### SUBDIVISION COMMITTEE REPORT

98034-(5) TBD

Revised Vesting Tentative Tract Map No.52584-1 Variance No. RVAR201300003 Conditional Use Permit No. RCUP201300081 Oak Tree Permit No. ROAK201300023 Environmental Assessment No. RENV201300138

### SUBDIVISION COMMITTEE REPORT RTR52584-1 06/09/16

TENTATIVE MAP DATED <u>05-10-2016</u> EXHIBIT MAP DATED <u>05-10-2016</u>

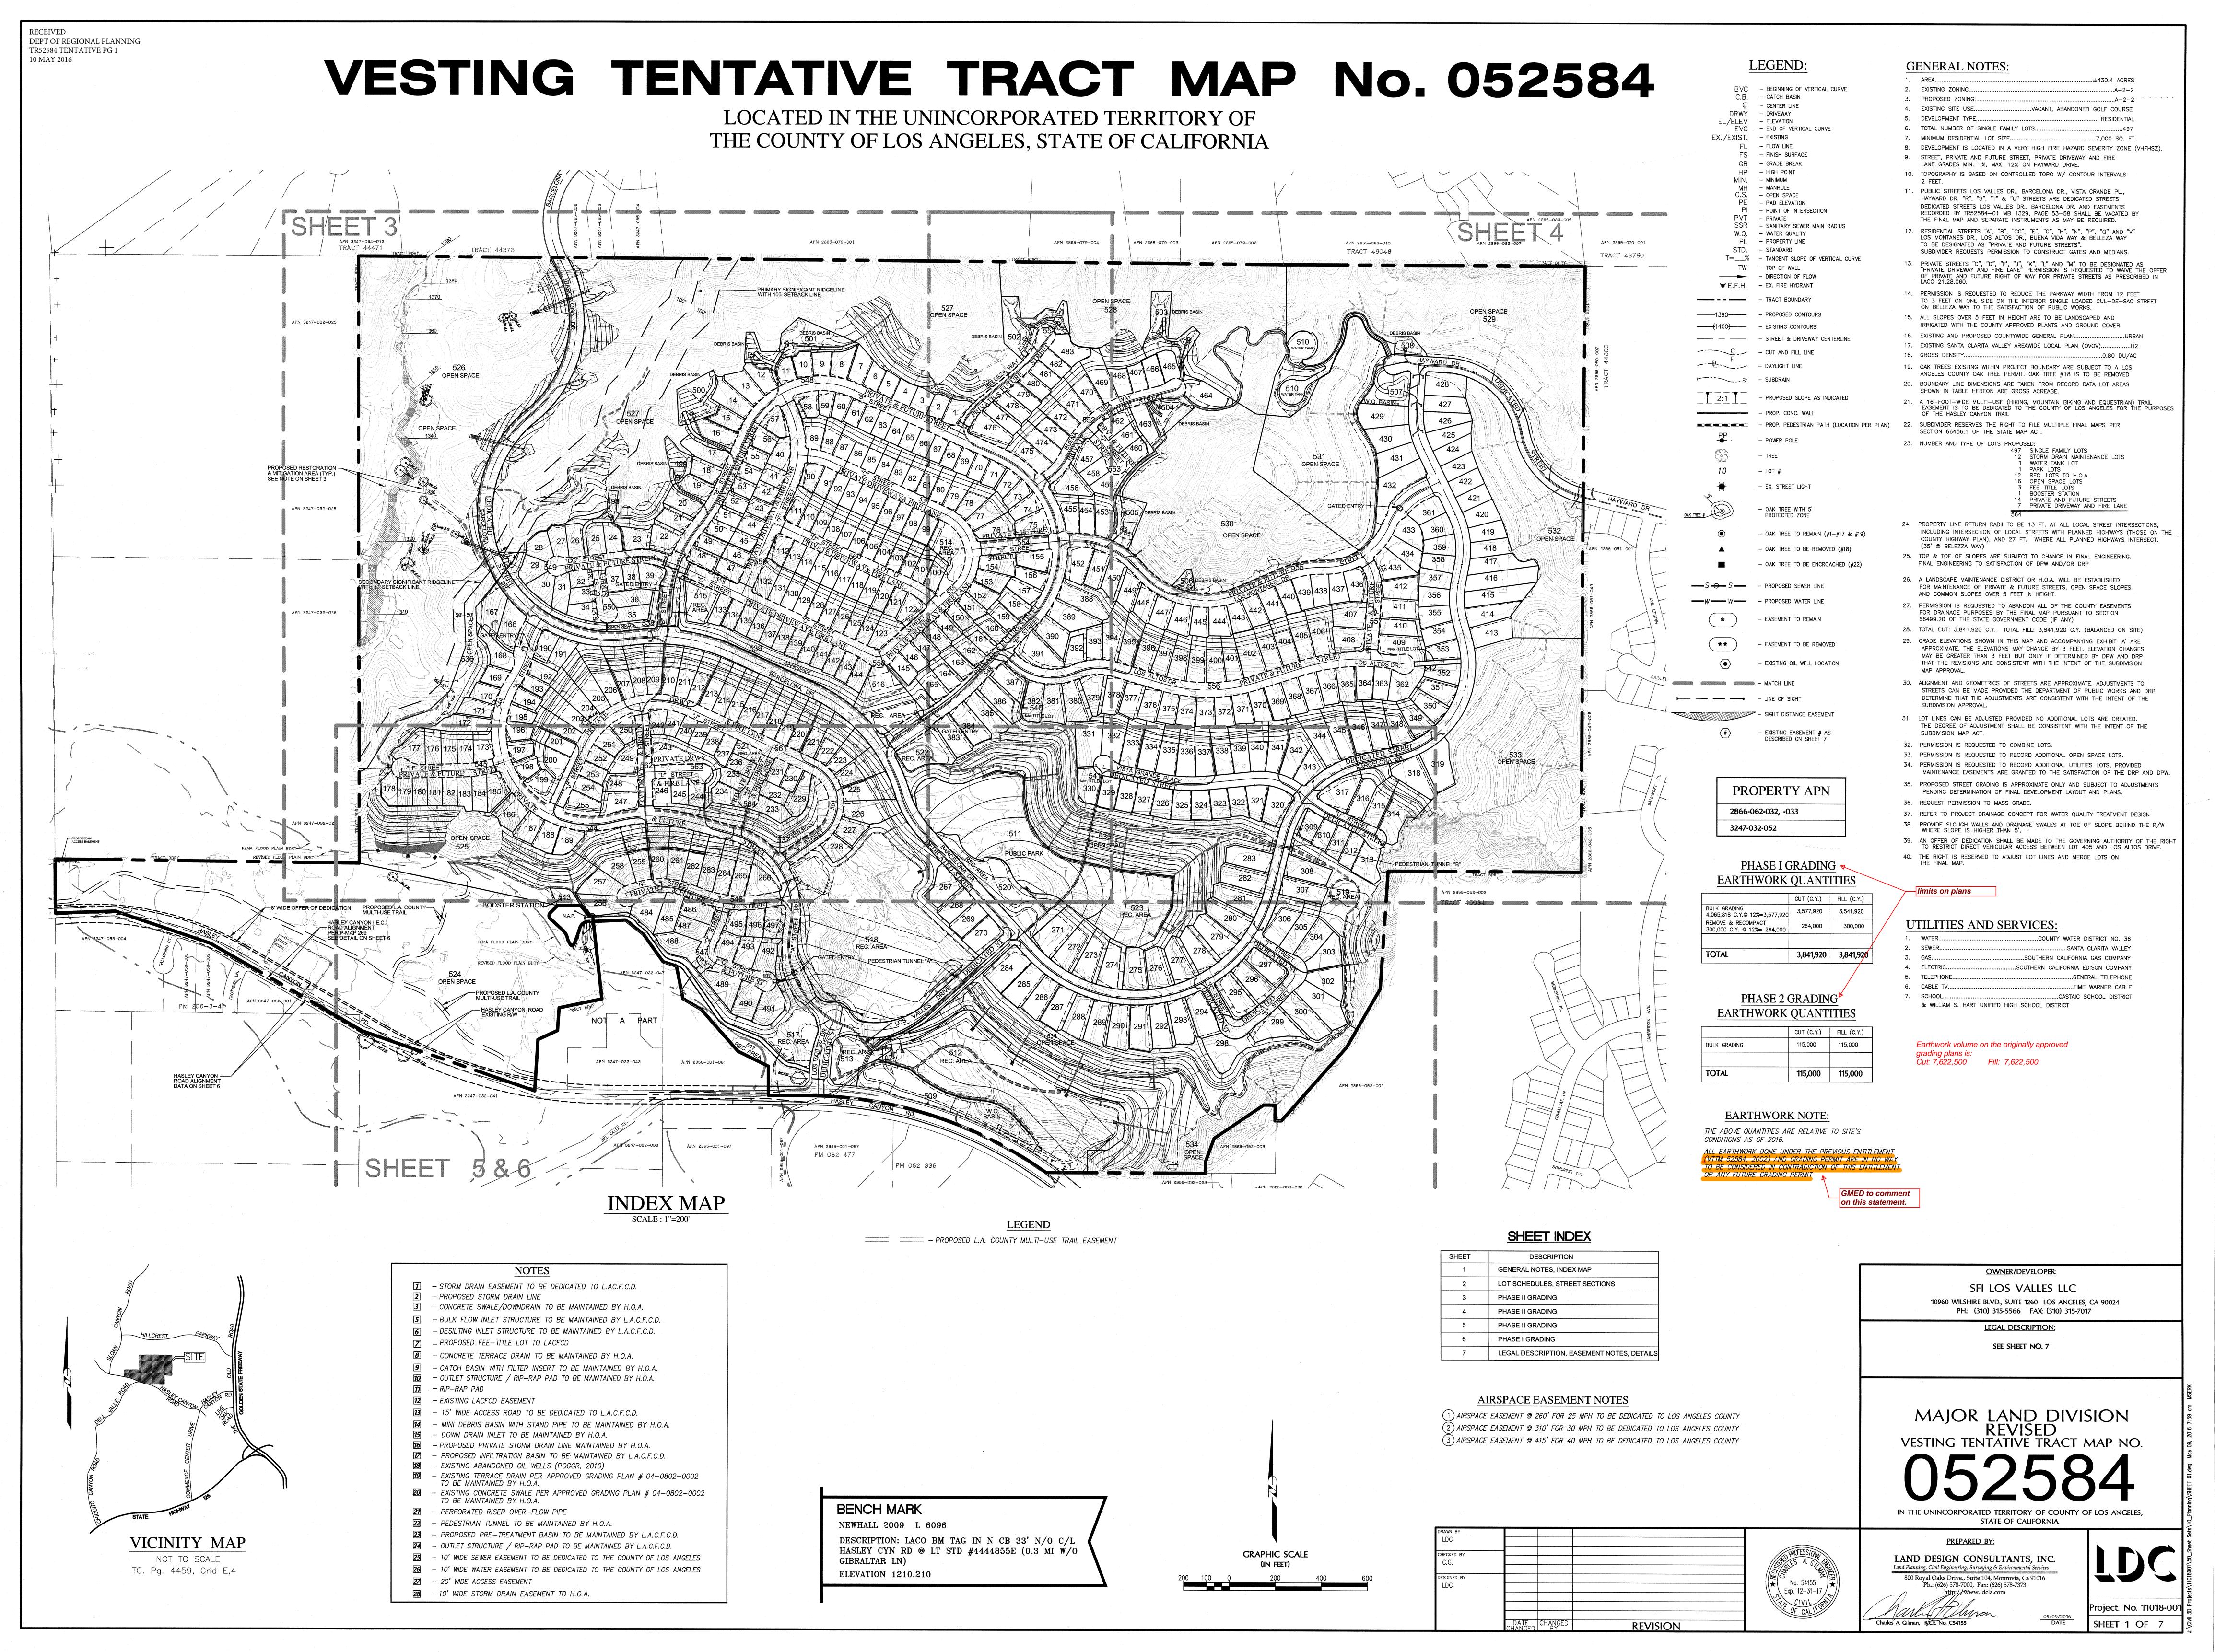
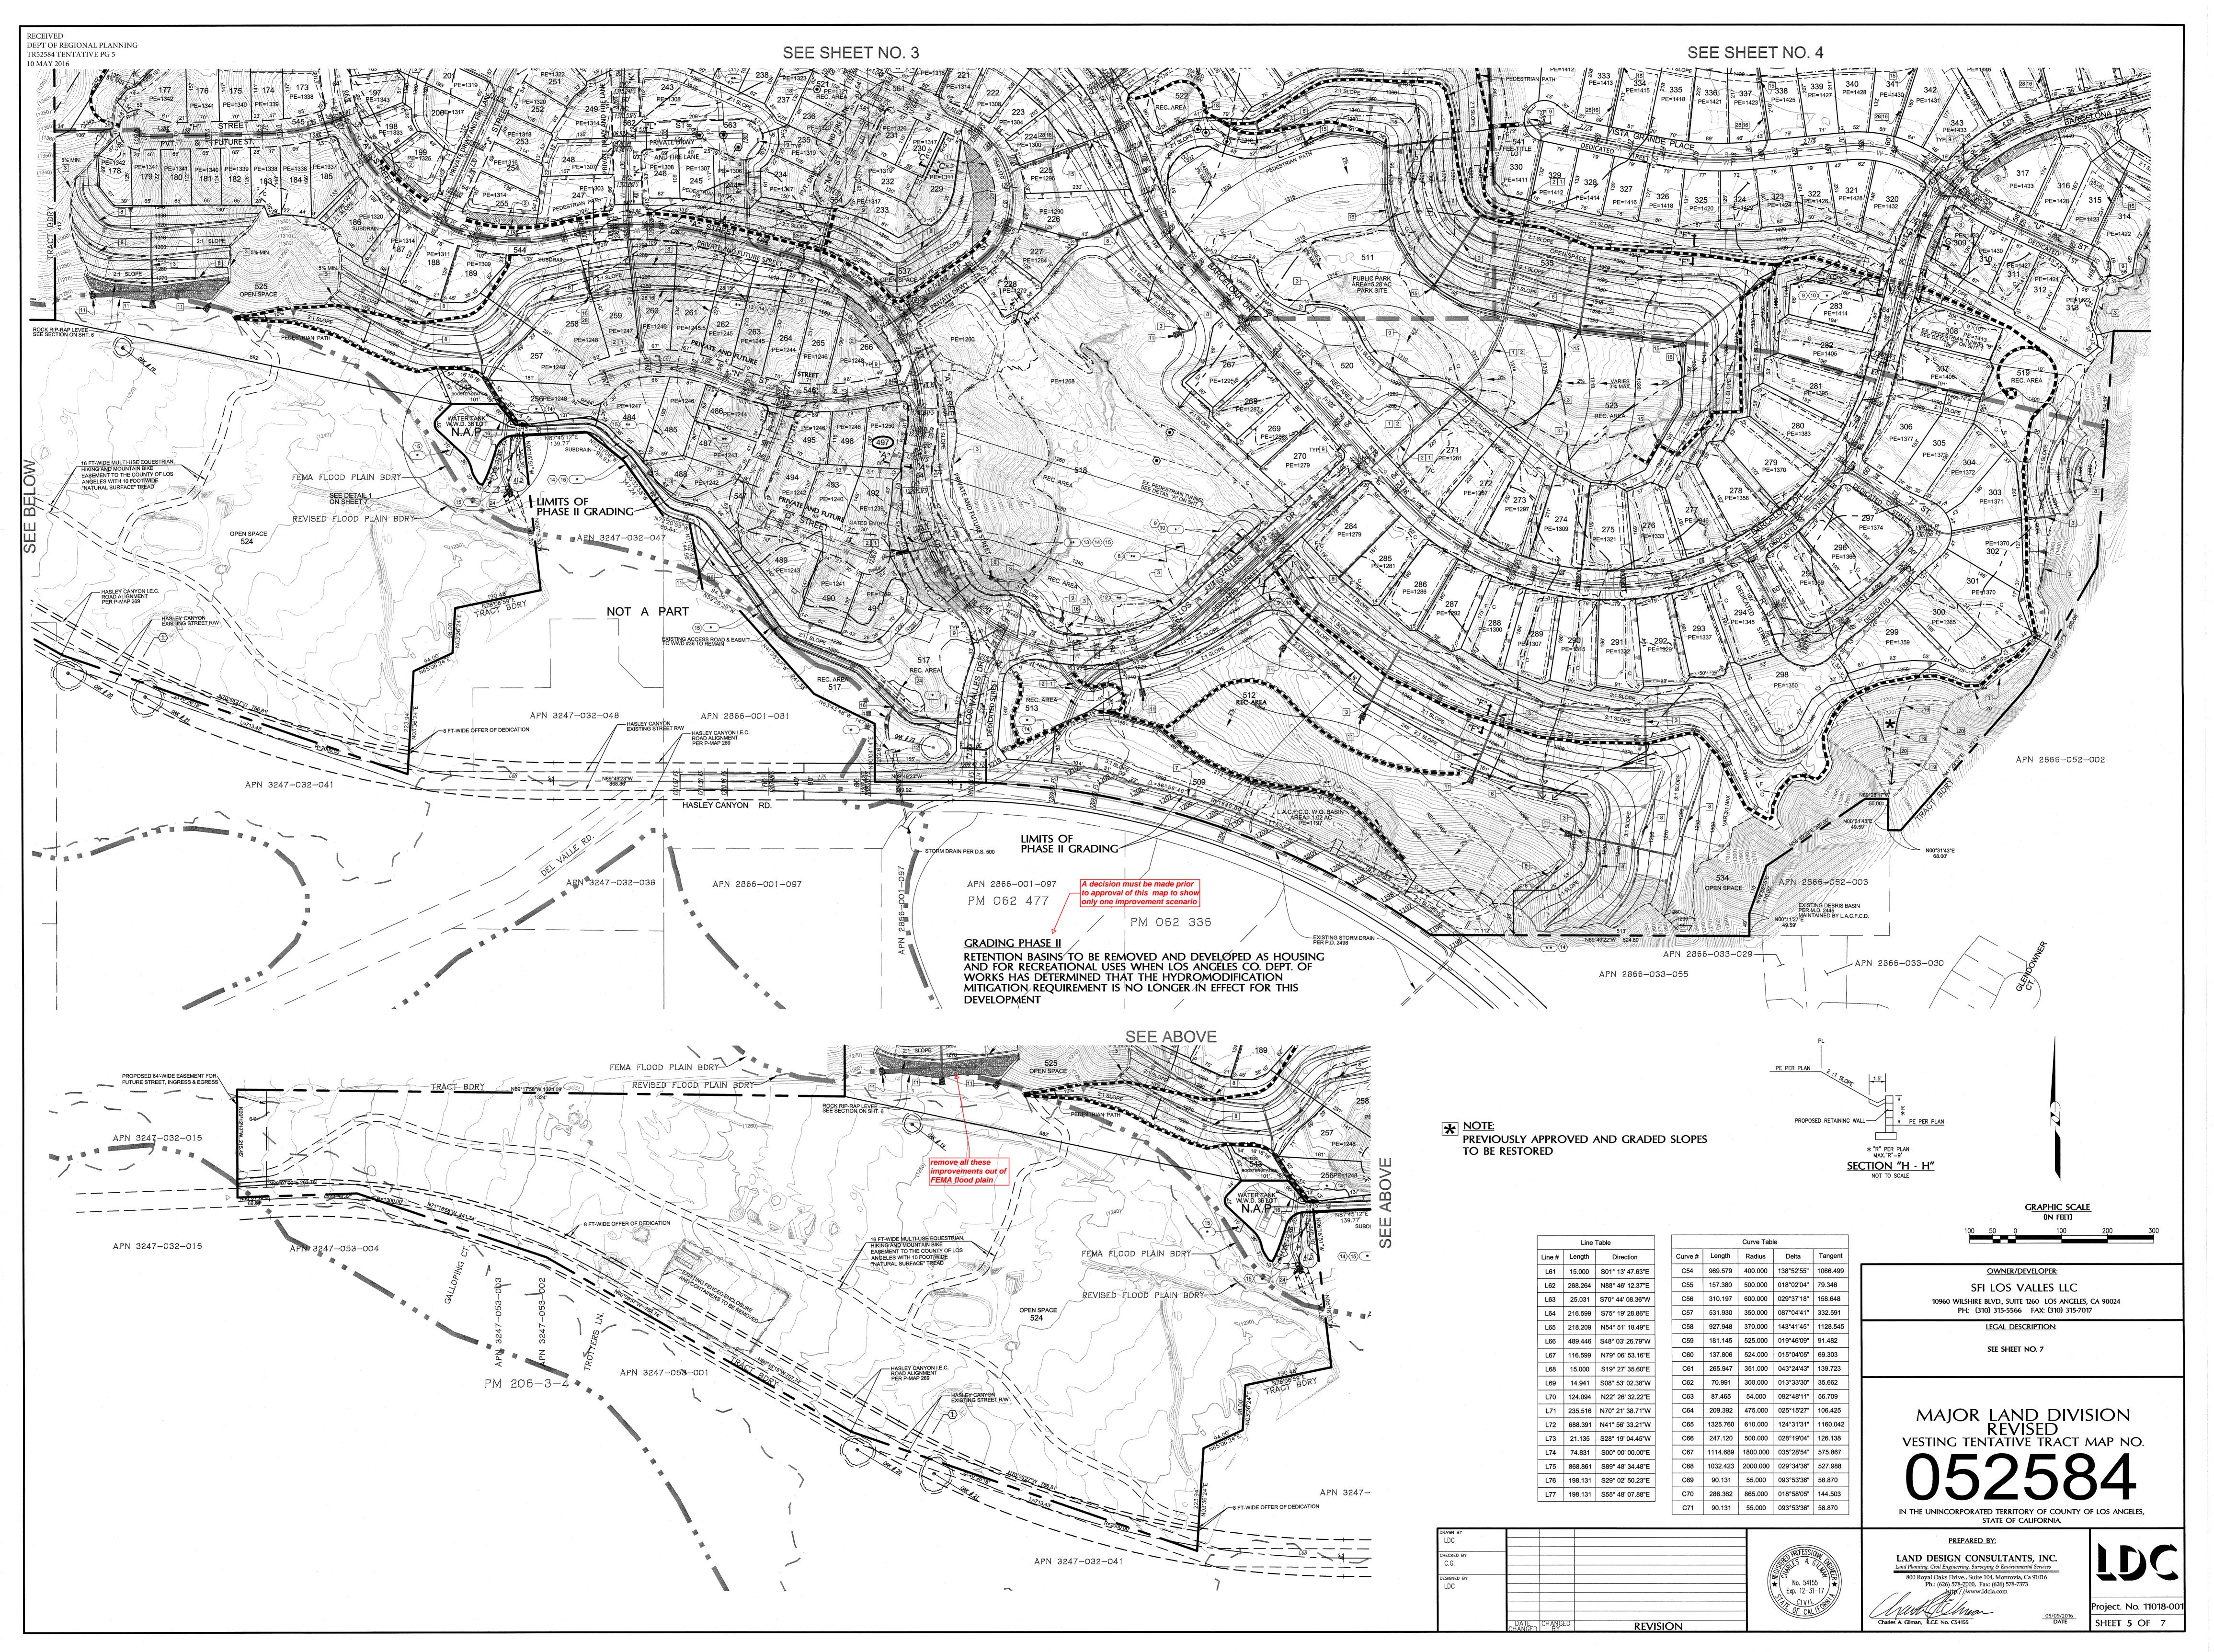
- 1. A revised tentative map and exhibit map is required to show the following additional items:
  - a. Earthwork volume, including cut, fill, import, and export, for all proposed improvement of this revised map. Also, show the volume for all graded areas. All volumes should be balanced with the volume on the previously approved tentative map or grading plans.

- b. Remove the "GRADING PHASE II" note shown on sheet 5 and conceptually show improvements that will be detailed on the final engineering plans. Hydromodification must be analyzed with hydrology prior to this map approval.

- c. Remove all proposed improvement shown inside FEMA boundary.
  - d. Provide a concrete swale with adequate drainage capacity behind the slough wall on detail on sheet 7.

- e. Rip-rap levee details shown on sheet 7 will be detailed on the final engineering plans.
- 2. Remediation note on sheet 7 must be included as a condition on GMED condition sheet and reflected on the grading conditions after GMED accepted it.

- 3. Additional comments on the map that was uploaded for your use at:
